Town of Parker Community Development Department  
Development Review Division  
Attention: **Julia Duncan**

Application Type: **Site Plan**  
Status: **First Referral**  
Application Name: Douglas 234 F6 L1 - Gas and Convenience Store  
Case/AP#: **SP21-063**  
Referral Received: June 20, 2021  
Comments Due: July 29, 2021

Review date: **July 20, 2021**  
Plan reviewer: **Randall L. Capra**, [rcapra@parkeronline.org](mailto:rcapra@parkeronline.org)  
Phone: 303.805.3169

**TOWN OF PARKER - FIRE/LIFE SAFETY:**

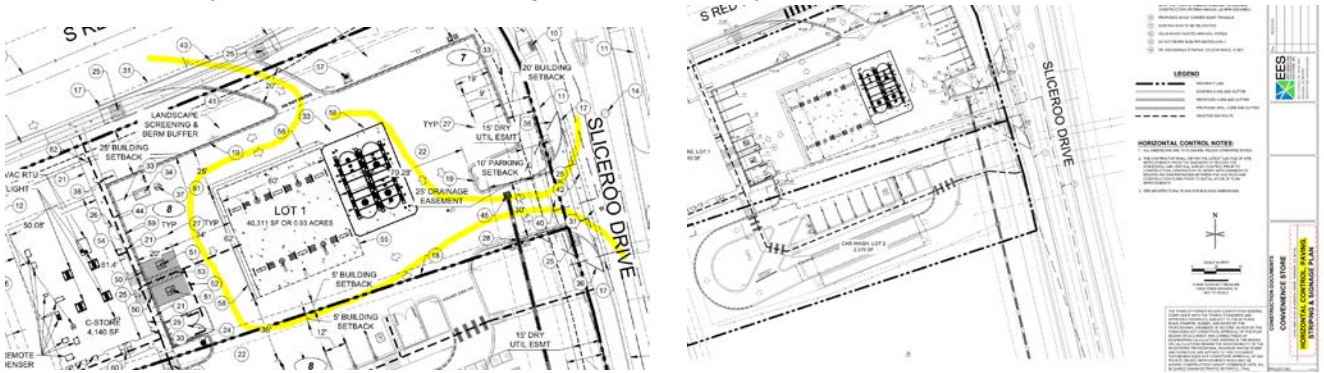
5. The applicant shall provide an auto turn analysis indicating that apparatus can navigate all portions of this site (both sides of the gas canopy); NO PARKING – FIRE LANE signage is required for any portion of the access where the 20-foot clear width requirement cannot be met. This is applicable for the loop around the canopy as well as for each entry. The access on each side of the canopy shall meet his requirement with no portion of the canopy encroaching into the required fire lane access road. See below for the areas required to be included in the auto turn analysis and address when resubmitting: *Not satisfied; applicant has stated that the auto-turn analysis and fire lane signage can be found on the Horizontal Plan in the CD set. In this case, the Horizontal Plan did not include auto-turn analysis for the area shown below in yellow. This issue shall be addressed when resubmitting.*

*What is needed specific to the auto-turn analysis:      What was provided on the Horizontal Control Plan:*

***Not satisfied; the applicant has not addressed this issue with submittal package #3; the applicant is required to respond to this issue prior to Fire Life Safety sign off. Satisfied; applicant has addressed with current submittal.***

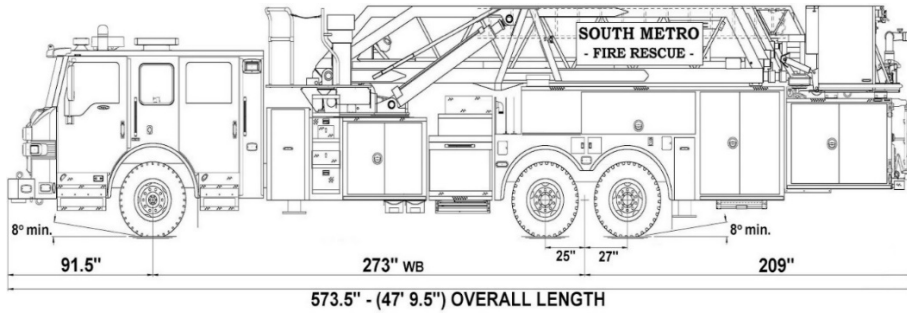
Note - An updated signature block has been created with regard to the utility drawing package; typically, this signature block is located on the cover sheet and the overall utility page of the water drawings. The signature block is noted below; address as applicable.
